To: Military Users of Alti-2 Test Chambers
Date: 10 May 2016
From: T.K. DONLE – Technical Director - CPS
Subject: Alti-2 Service Bulletin – SB-0005A
Equipment: Alti-2 Test Chambers – Reference Altimeter (P/N: C-01181)

Service Bulletin – Product Recall

Purpose: Notification of Component Manufacturer’s Recall of Reference Altimeter (C-01181)

Service Bulletin No. 13
March 25, 2016

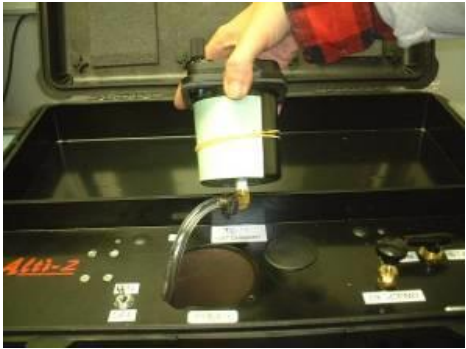
Issue: Reference Altimeter C-01181 (United Instruments 5934 Series) may display incorrect altitude

Affected Alti-2 Products: TC-10 SNs: T151930, T154911, T155601
 TC-21/22 SNs: T154910, T156003, T156004, T154912, T154913, T154914,
 T154915, M119358 (RMA), U156240, T151931, T155602

Description: A manufacturing defect in the OEM component may cause the instrument to display higher than actual altitude. United Instruments Service Bulletin 13 is included for reference.

Customer Action: Follow the guidance prescribed in the CPS Service Bulletin Letter relating to SB-0005A

Shipping Instructions: Label Reference Altimeter with CPS-RMA# and carefully package the unit in a container no smaller than 8”x8”x8”.
